SUBJECT: DRESDEN NUCLEAR POWER STATION, UNITS 2 AND 3 - STAFF
ASSESSMENT OF INFORMATION PROVIDED PURSUANT TO TITLE
10 OF THE *CODE OF FEDERAL REGULATIONS* PART 50, SECTION 50.54(f),
SEISMIC HAZARD REEVALUATIONS RELATING TO RECOMMENDATION 2.1
OF THE NEAR-TERM TASK FORCE REVIEW OF INSIGHTS FROM THE
FUKUSHIMA DAI-ICHI ACCIDENT (TAC NOS. MF3877 AND MF3878)

STAFF ASSESSMENT BY THE OFFICE OF NUCLEAR REACTOR REGULATION

RELATED TO SEISMIC HAZARD AND SCREENING REPORT

DRESDEN NUCLEAR POWER STATION, UNITS 2 AND 3

Figure 3.3-1 Plot of Staff's and Licensee's Base Case Shear-Wave Velocity Profiles: (a) Velocity profiles to a depth of 5000 ft [1524 m], (b) Velocity profiles to a depth of 500 ft [152 m] for the Dresden site

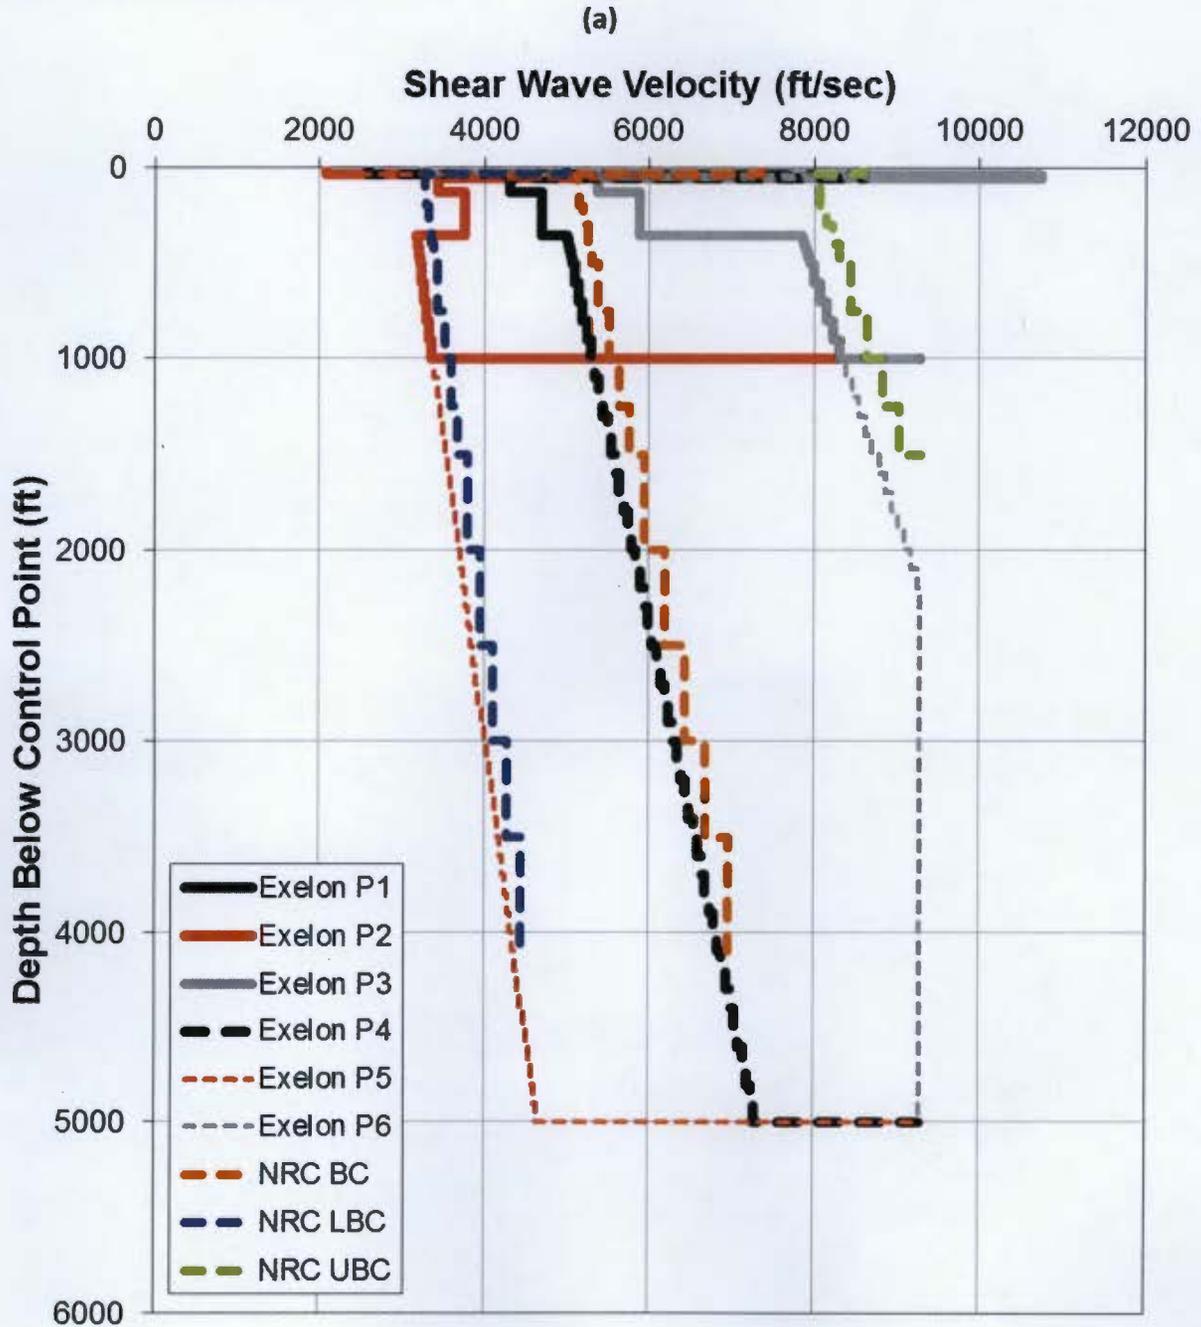
For each of these two best estimate profiles with different depths to the base rock layer, the licensee developed upper and lower base case profiles for a total of six site base case profiles. The licensee developed the upper and lower base case profiles for each of the two best estimate profiles using a natural log standard deviation of 0.20 for the upper 360 ft [110 m] and 0.35 for greater depths. Figure 3.3-1 of this assessment shows the licensee's shear-wave velocity base case profiles.

Because limited velocity information is available for the Dresden site, the staff used three shear wave velocity profiles. For the depth interval between the control point and 50 ft [15 m] below the control point, the staff used an average of the measured compression wave velocities and then assumed a Poisson's ratio to develop its shear wave velocity profile. For depths between 50 ft [15 m] below the control point and the base of the profile, the staff assumed the shear wave velocity increased linearly, consistent with guidance from the SPID. To capture the uncertainty in the depth to base rock, the staff used a depth of 4,100 ft [1250 m] for its lower and middle base case profiles and a depth to base rock of 1,500 ft [457 m] for its upper base case profile. The staff introduced additional uncertainty in the depth to base rock by randomizing the depth to base rock by ± 30 percent of the total profile thickness. Figure 3.3-1 of this assessment shows the staff velocity profiles compared to the profiles developed by the licensee.

The largest difference between the staff's and licensee's velocity profiles is in the upper 35 to 360 ft [11 – 110 m], which is primarily due to defining the control point at slightly different elevations and the staff applying larger uncertainty to develop its lower and upper base case profiles. Regarding the control point elevation, the reactor building foundation is supported on Ordovician Divine limestone at an elevation of 472.5 ft [144 m]. The staff used the top of this geologic unit as the control point, while the licensee used the top of the uppermost rock unit, the Pennsylvanian Pottsville Formation sandstone as the control point (515 ft [74.7 m]). Additionally, rather than develop six base case profiles, the staff developed only three profiles, as described above. To develop its lower and upper base case velocity profiles, the staff used a natural log standard deviation of 0.35, which is the value recommended by the SPID for sites with limited subsurface data.

Figure 3.3- 1 Plot Comparing the Staff's and the License's Median Amplification Functions and Uncertainties for two input loading levels for the Dresden site

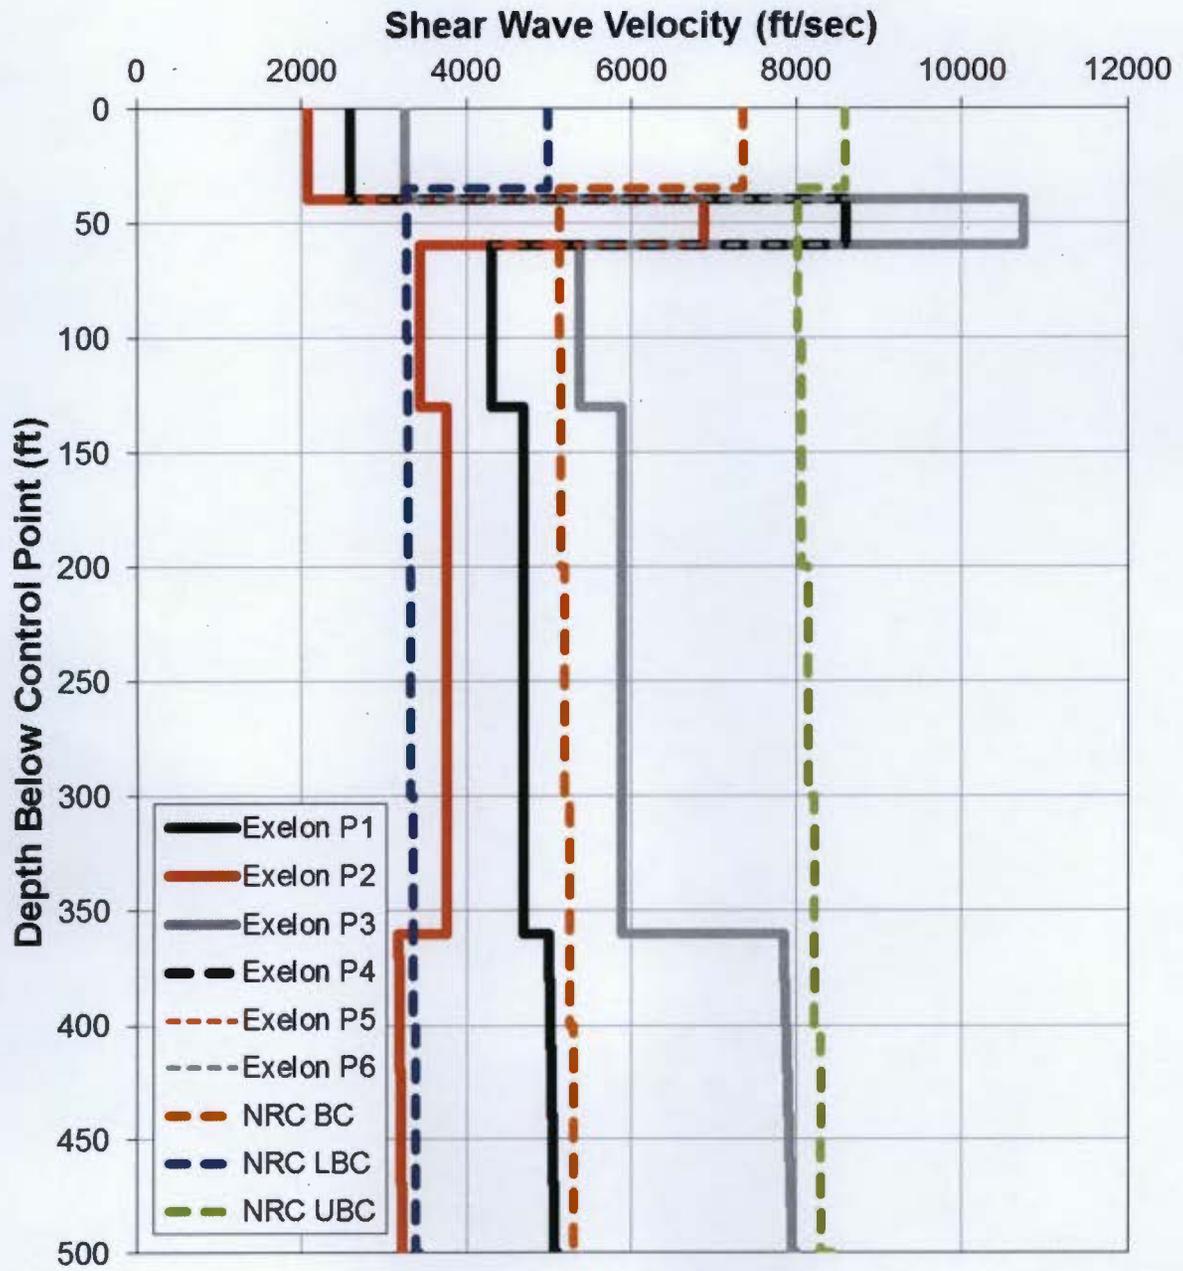
Figure 3.3-2 of this assessment shows a comparison of the staff's and licensee's median site amplification functions and uncertainties (± 1 standard deviation) for two of the eleven input loading levels. The comparison of amplification functions is for the licensee's profile P1 and the staff's base case profile. The licensee's amplification functions are moderately higher than the staff's amplification functions near 1 Hz and between 5 – 15 Hz. The differences above 5 Hz are primarily due to the different control point elevations assumed by the staff and licensee while the differences at 1 Hz are due to the licensee's use of two sets of profiles with different depths to bedrock at 1,000 ft [305 m] and 5,000 ft [1524 m]. The staff used a depth to base rock of 4,100 ft [1250 m] for its lower and middle base case profiles and a depth to base rock of 1,500 ft [YYY m] for its upper base case profile.

Figure 3.3-2 Plot Comparing the Staff's and the Licensee's Mean Control Point Hazard Curves at a Variety of Frequencies for the Dresden site

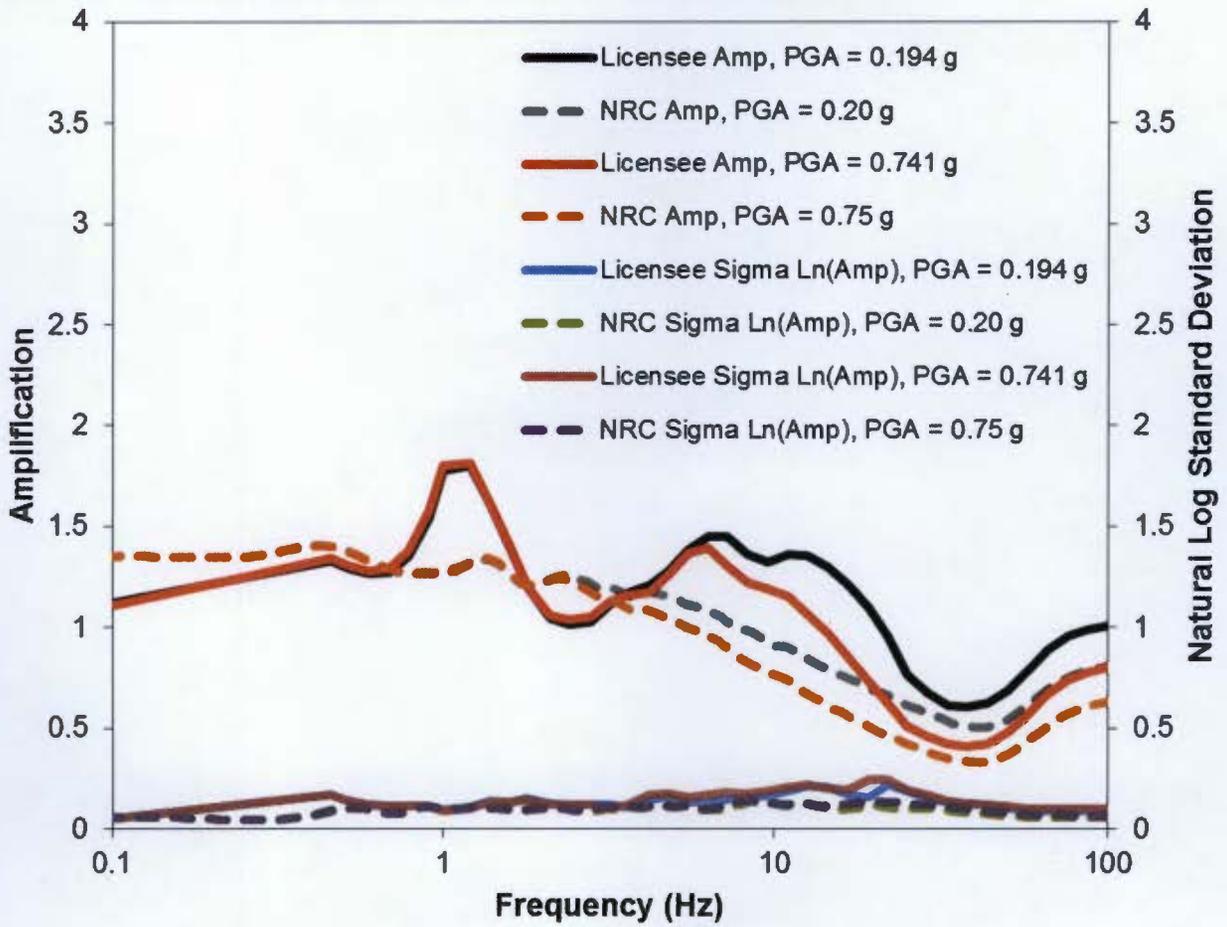
Overall, the licensee's approach to modeling the subsurface rock properties and their uncertainty results in higher site amplification factors, particularly at high frequencies. As shown in Figure 3.3-3 of this assessment, these differences in the site response analysis do not have a significant impact at 1 Hz and only a moderate impact above 5 Hz on the control point seismic hazard curves and the resulting GMRS, as discussed below. Appendix B of the SPID provides guidance for performing site response analyses, including capturing the uncertainty for sites with less subsurface data; however, the guidance is neither entirely prescriptive nor comprehensive. As such, alternative approaches in performing site response analyses, including the modeling of uncertainty, are acceptable for this application.

Figure 3.4-1 Comparison of the Staff's GMRS with Licensee's GMRS and the SSEs for the Dresden site

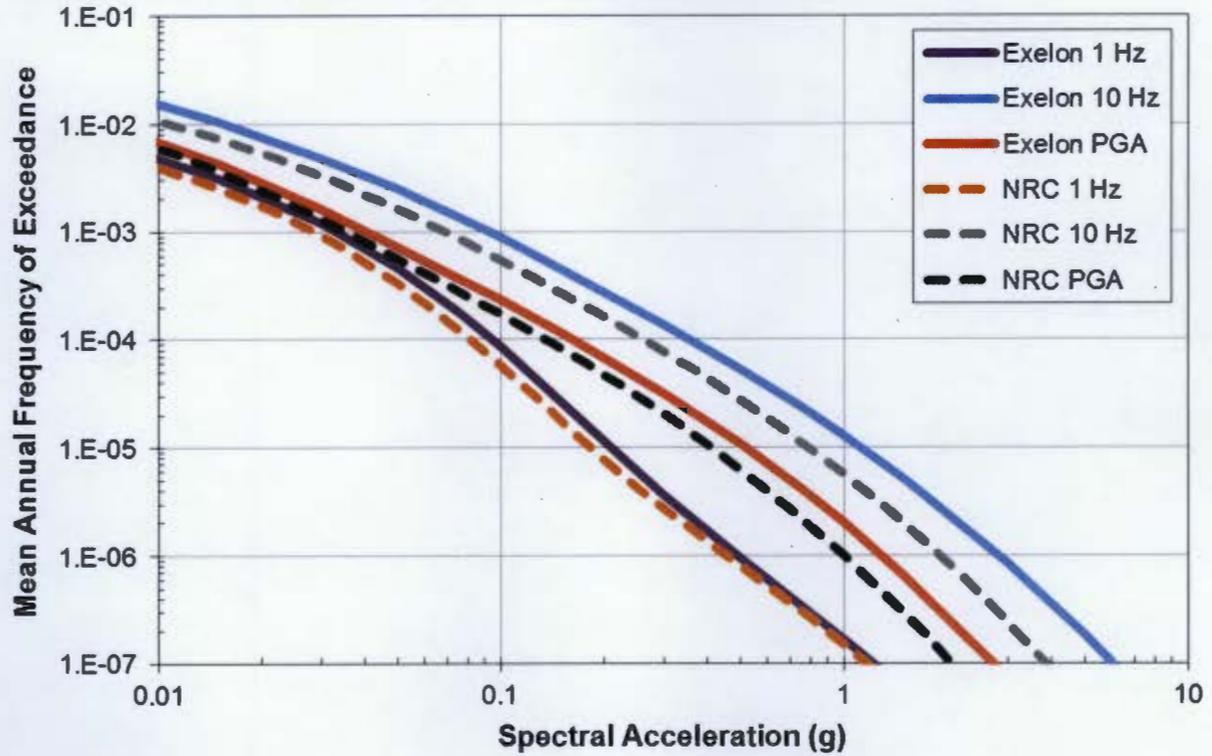
The staff independently calculated the 10^{-4} and 10^{-5} UHRS using the results of its confirmatory PSHA and site response analyses, as described in Sections 3.2 and 3.3 of this staff assessment, respectively. Figure 3.4-1 of this assessment shows a comparison of the GMRS determined by the licensee to that determined by the staff.

As shown in Figure 3.4-1 below, the licensee's GMRS shape is generally similar to that calculated by the staff at frequencies less than 5 Hz. However, NRC staff's confirmatory GMRS is somewhat lower than the licensee's at frequencies above 5 Hz. As described above in Section 3.3, the staff concludes that these differences over the higher frequency range are primarily due to the differences in the site response analyses performed by the licensee and staff. The staff concludes that these differences are acceptable for this application because the licensee followed the guidance provided in the SPID with respect to both the PSHA and site response analysis for the Dresden site.

The staff confirms that the licensee used the present-day guidance and methodology outlined in RG 1.208 and the SPID to calculate the horizontal GMRS, as requested in the 50.54(f) letter. The staff performed both a PSHA and site response confirmatory analysis and achieved results generally consistent with the licensee's horizontal GMRS. As such, the staff concludes that the GMRS determined by the licensee adequately characterizes the reevaluated hazard for the Dresden site. Therefore, this GMRS is suitable for use in subsequent evaluations and confirmations, as needed, for the response to the 50.54(f) letter.
